ADDENDUM #4

15 March 2024

RE: Sherman School Roof Recovery Project

Job No. 22067

Roof Repair Plan

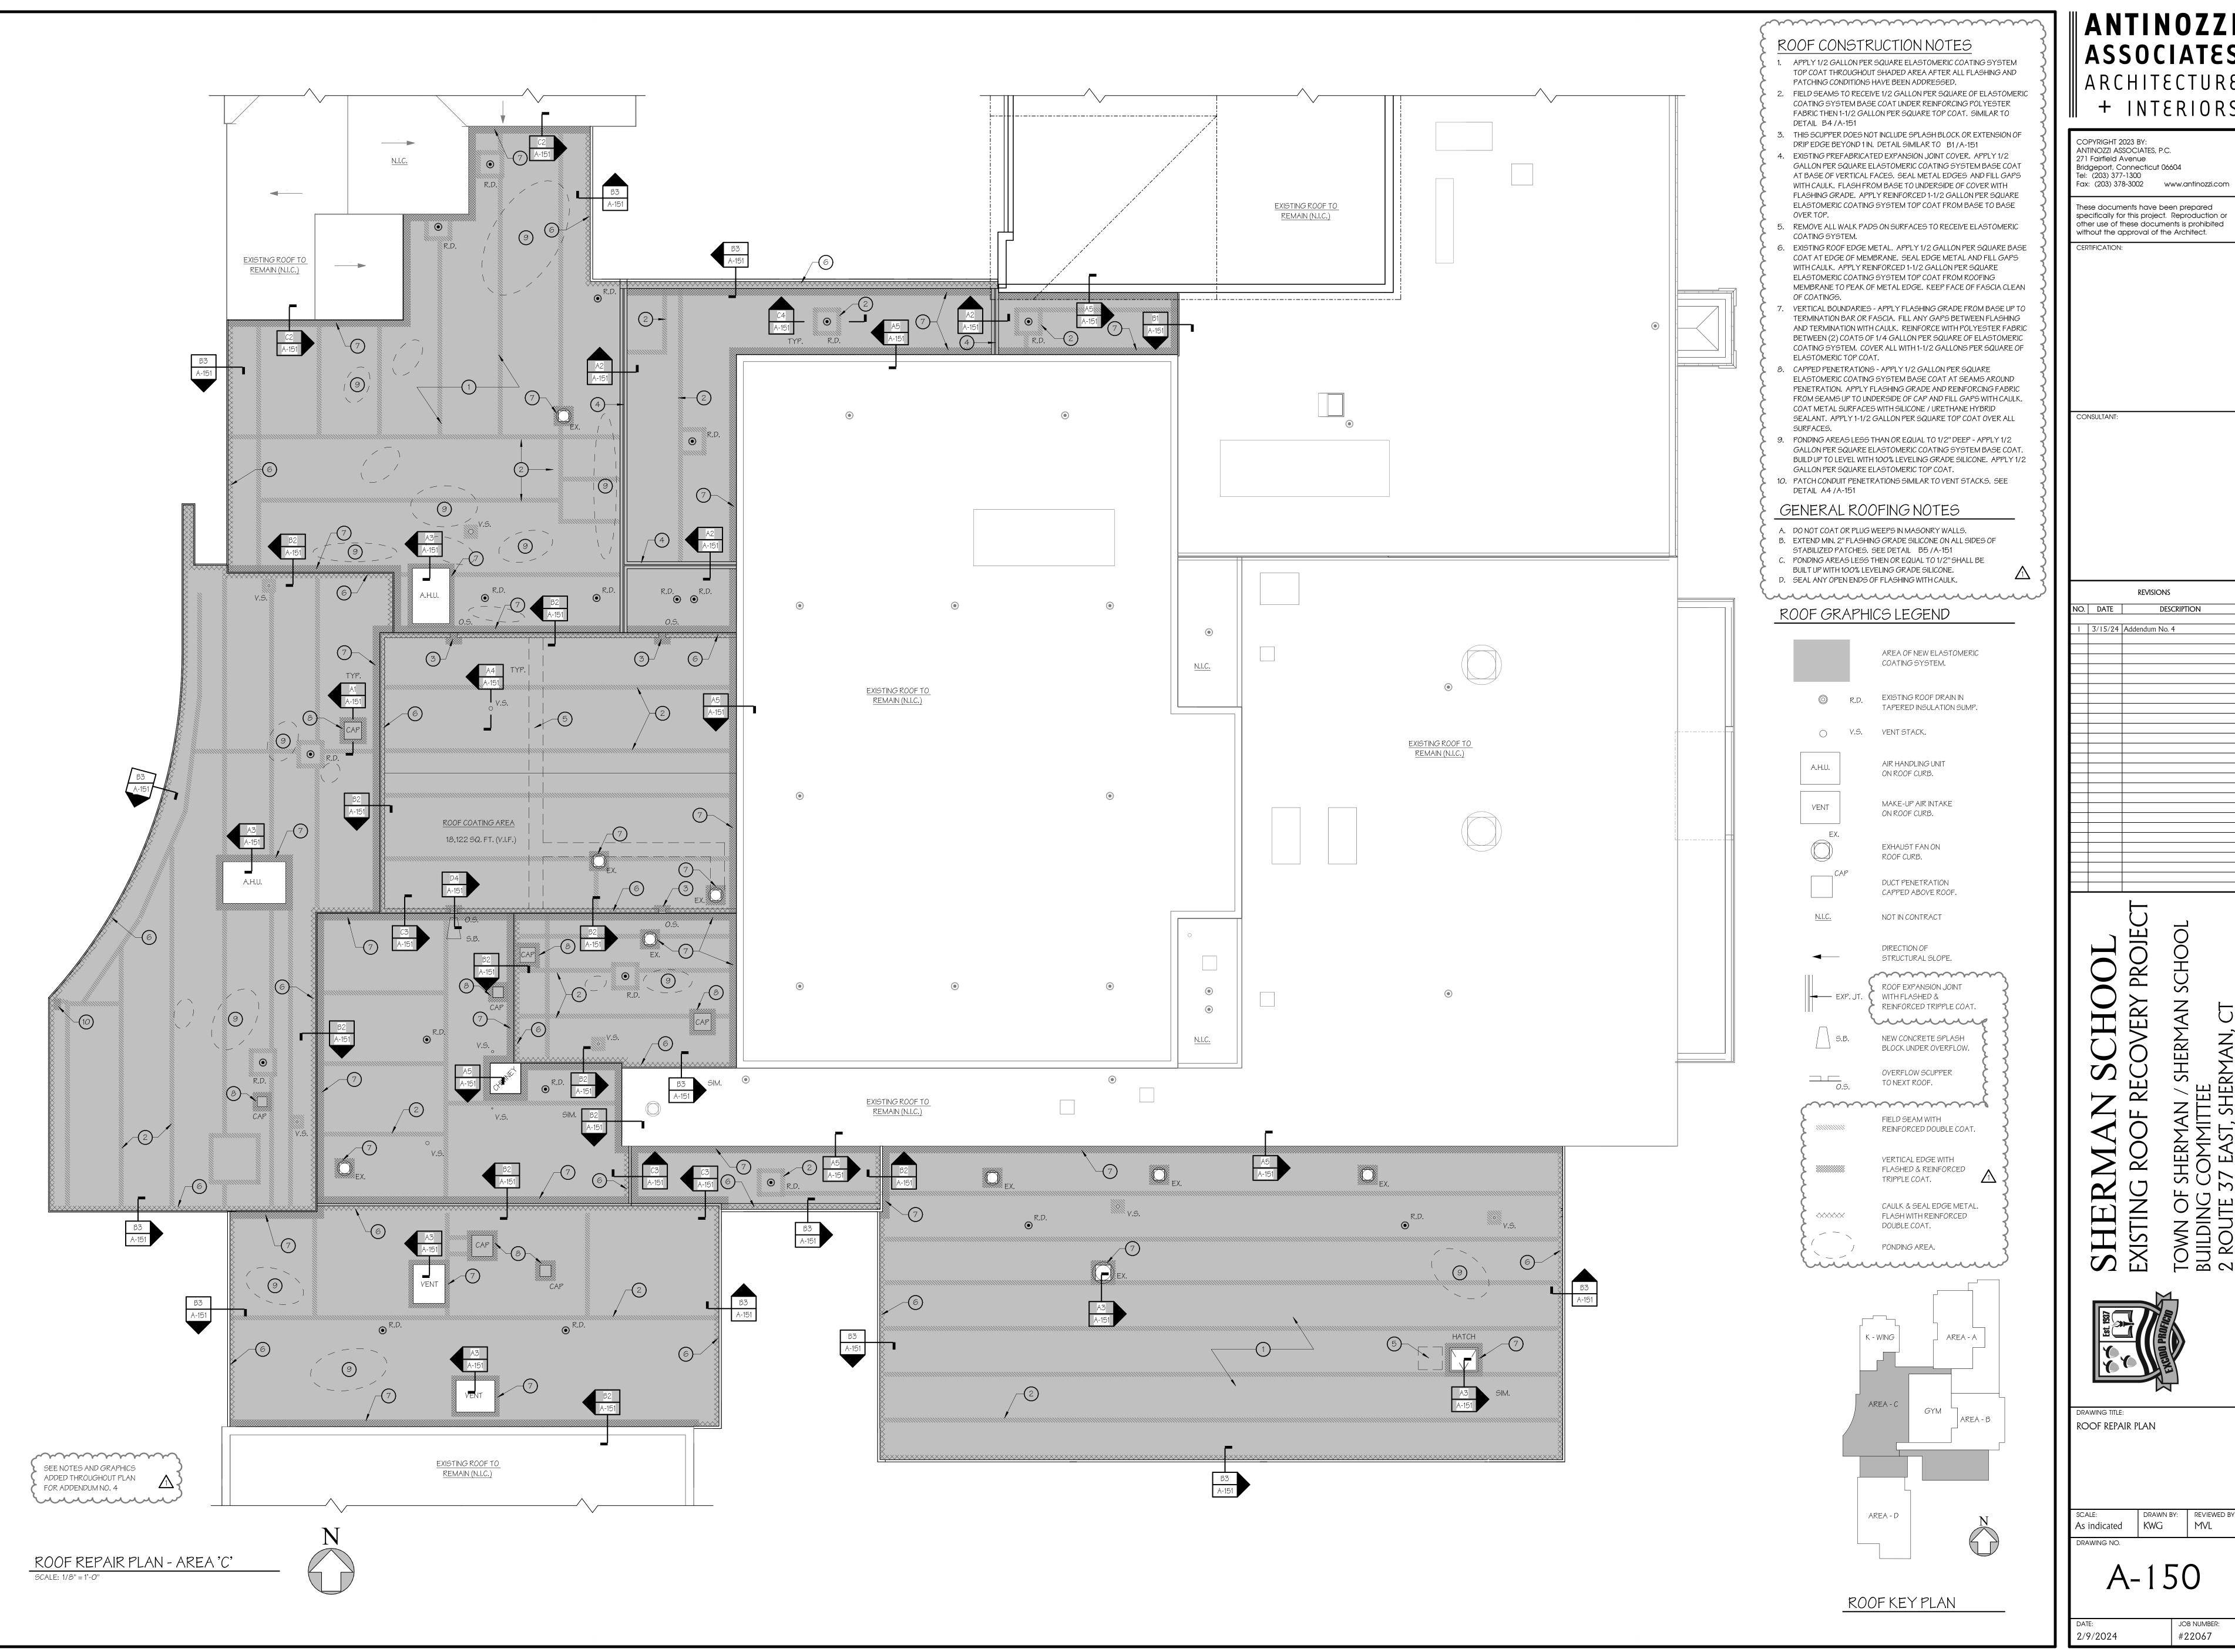
1) A-150 Roof Repair Plan, revised 03/15/2024 to quantify treatment of seams, perimeter system terminations, and openings in metal flashing components.
